## Addendum #2 Request for Bids (RFB) 2020-03 Isle of Palms Marina Rehabilitation August 28, 2020

This addendum is intended to provide further clarification to the Bid Documents for this project, dated July 10, 2020. Specifically, this addendum intends to address the bidder questions received by the City. Also, note a revised bid form is provided along with several attachments. The bid due date is also hereby extended to September 11, 2020. Bids shall be due by 11am local time on this date.

E1

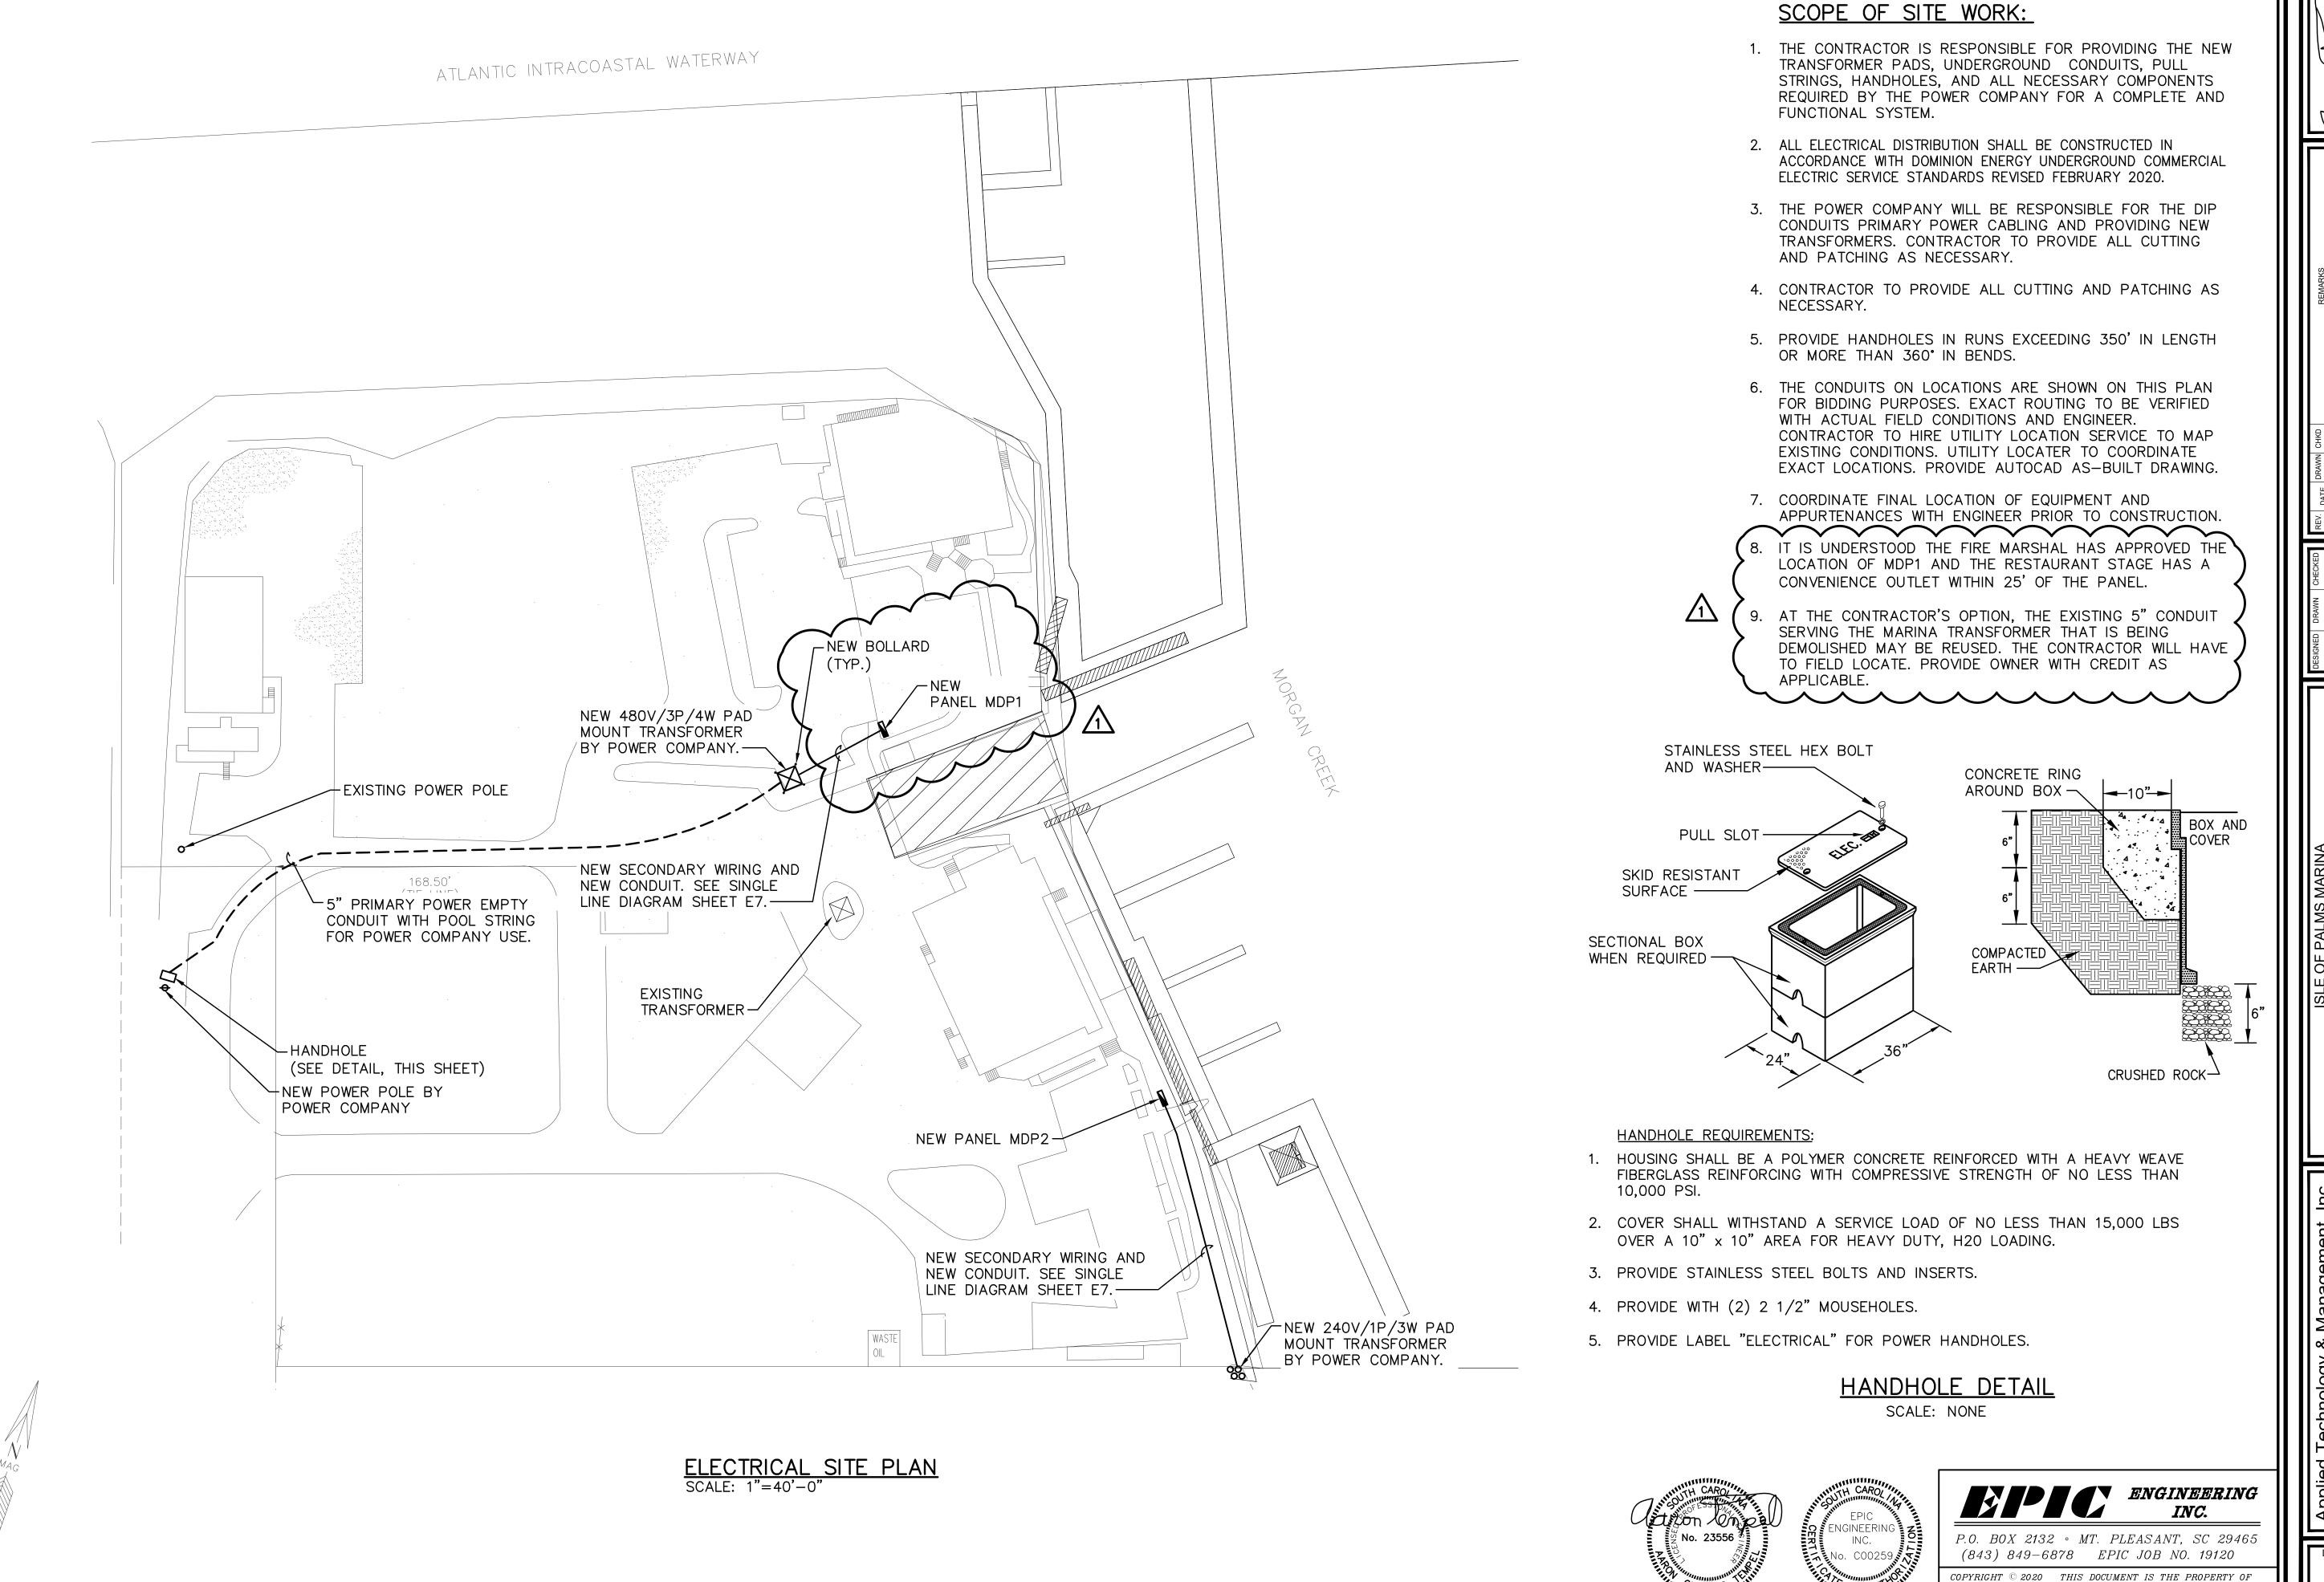
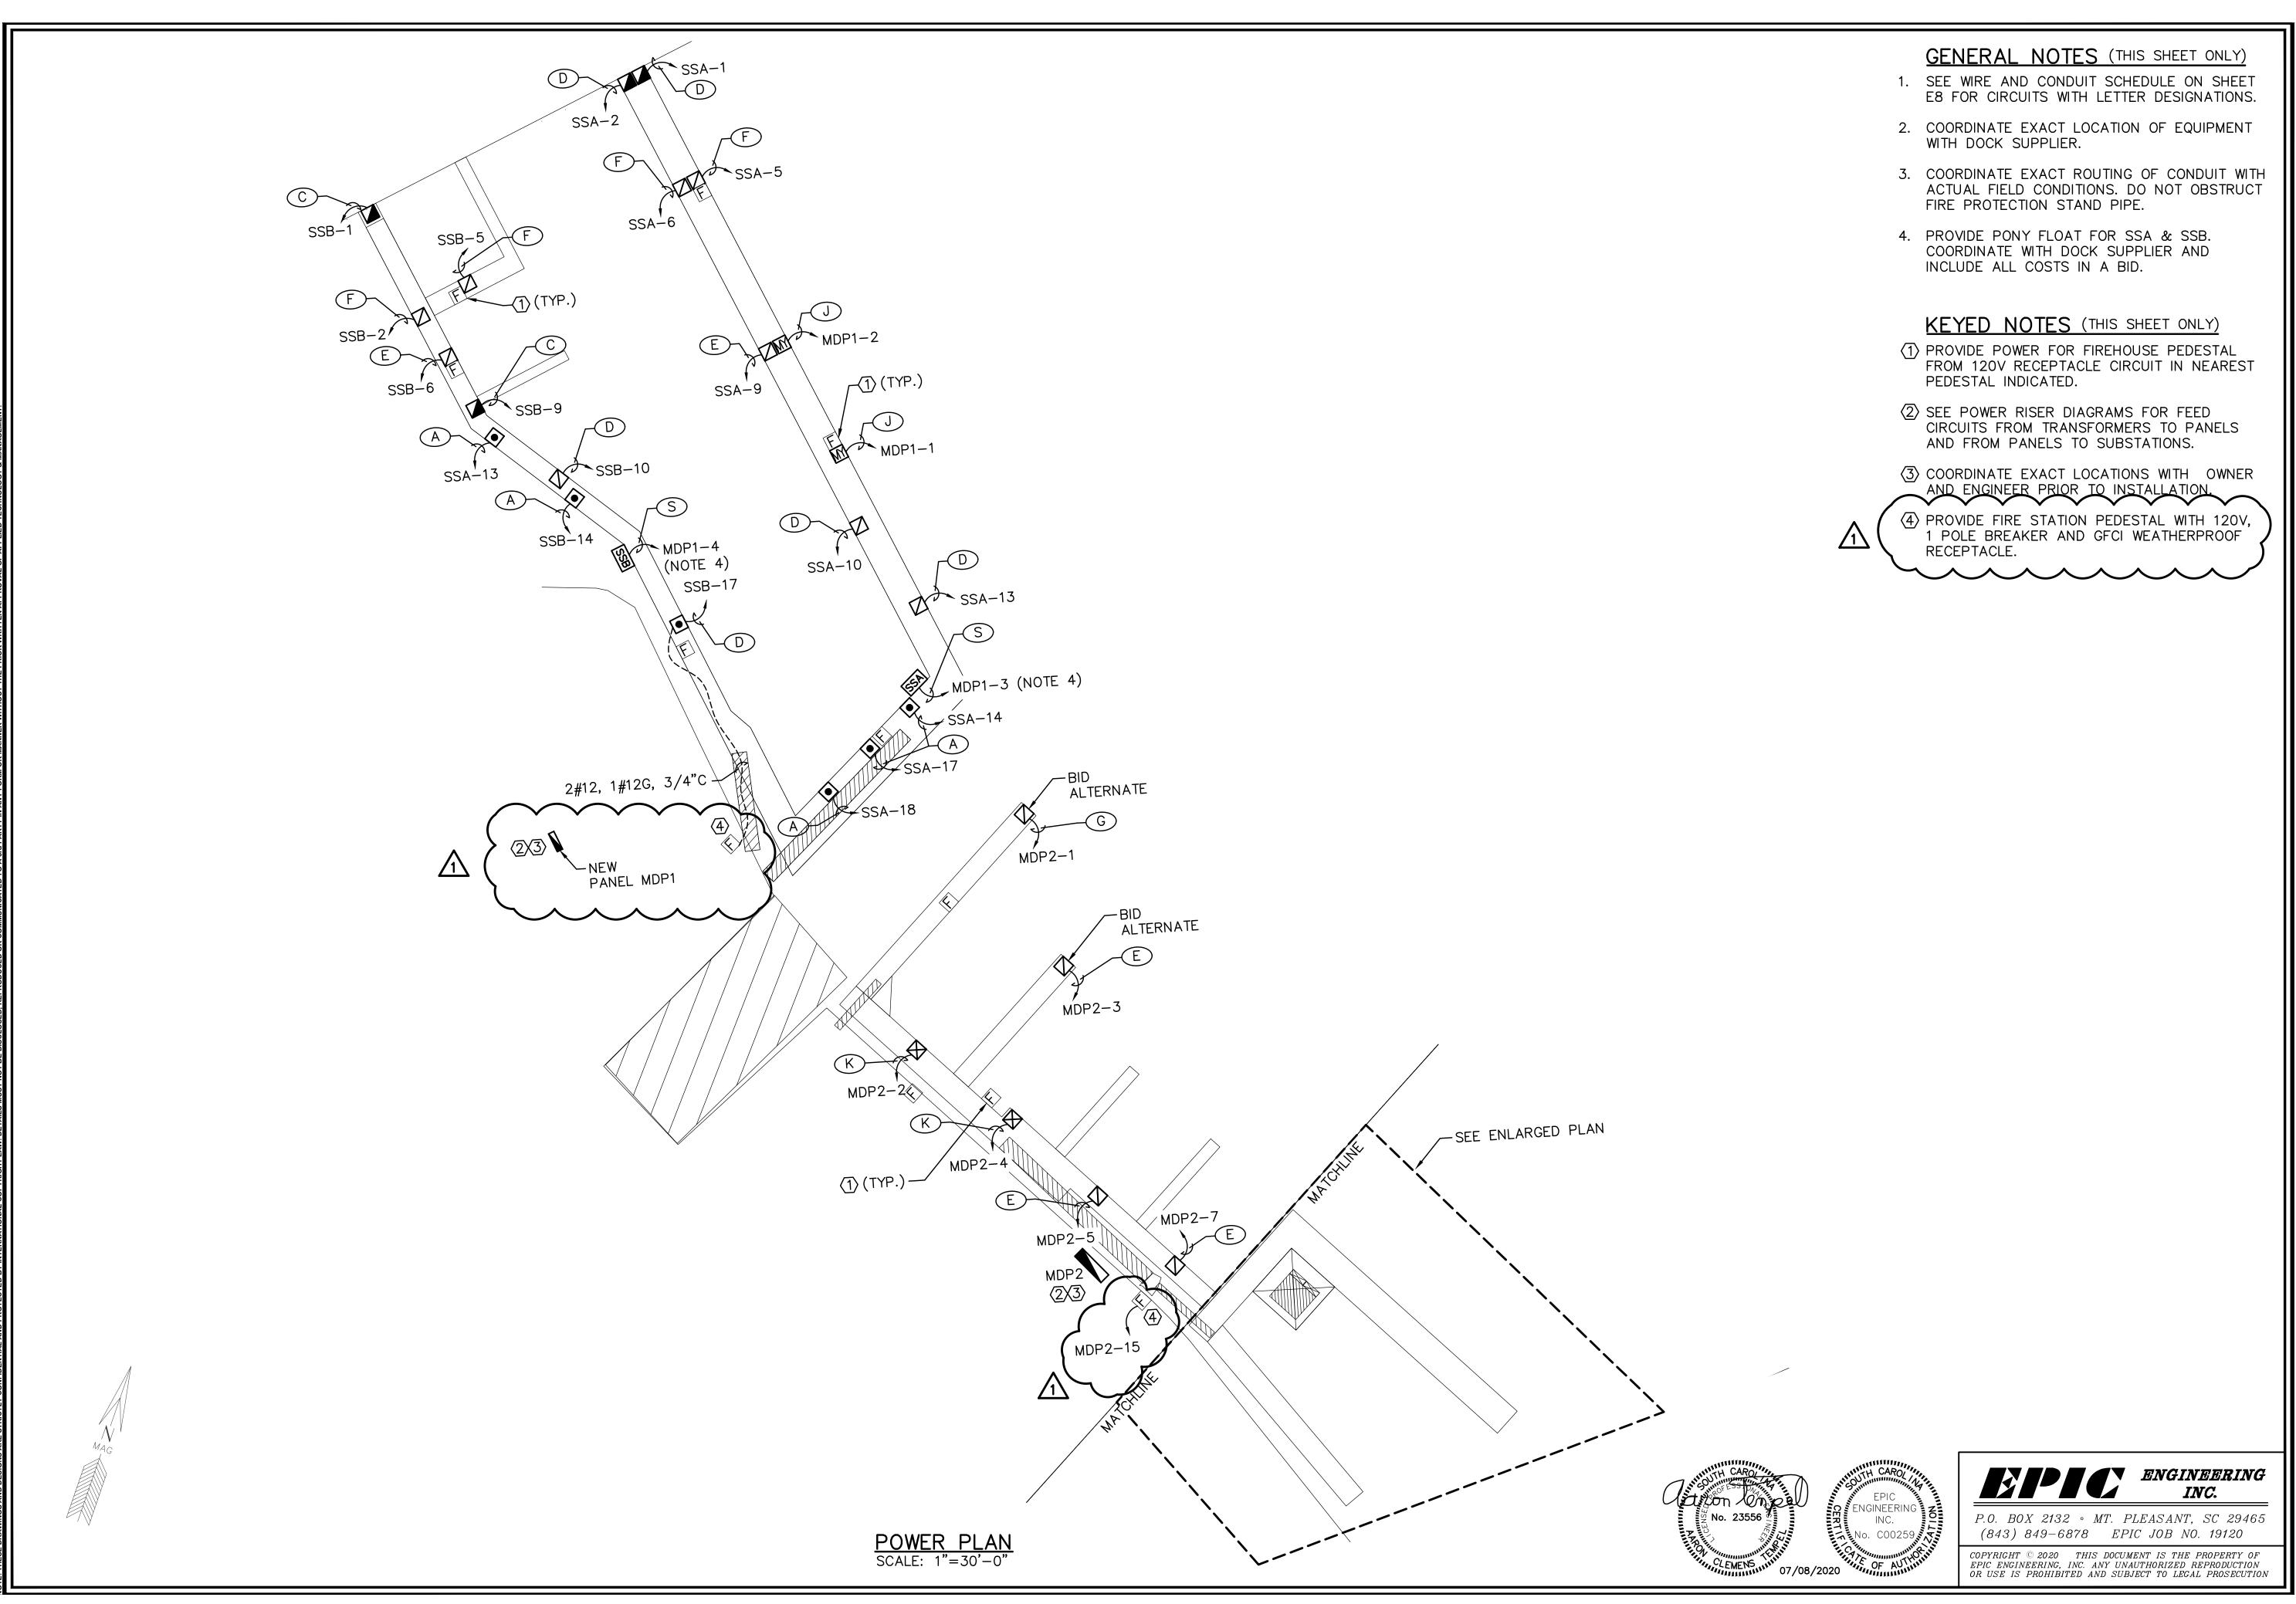
Q: Note #8 on Sheet E1 indicates that all floating dock cables shall be installed in "...utility trench within the dock system". Also, there's a note under the "Wire and Conduit Schedule" on Sheet E8 which states essentially the same thing. We've never seen a wood dock system come with conduits furnished in them. Further, we've never installed Type "G" cable within conduits in wood dock systems. That

- type cable is used primarily because it has a very heavy duty outer jacket and is generally considered to be suitable to be installed directly in the wood dock framing. Please clarify.

- A: The cable from the transformer to the main distribution panels is to be type THHN/THWN in conduit. The cables from the main distribution panel to the substation and throughout the rest of the marina is to be type G-GC. Conduit is only necessary if more support than the dock system can provide is required.
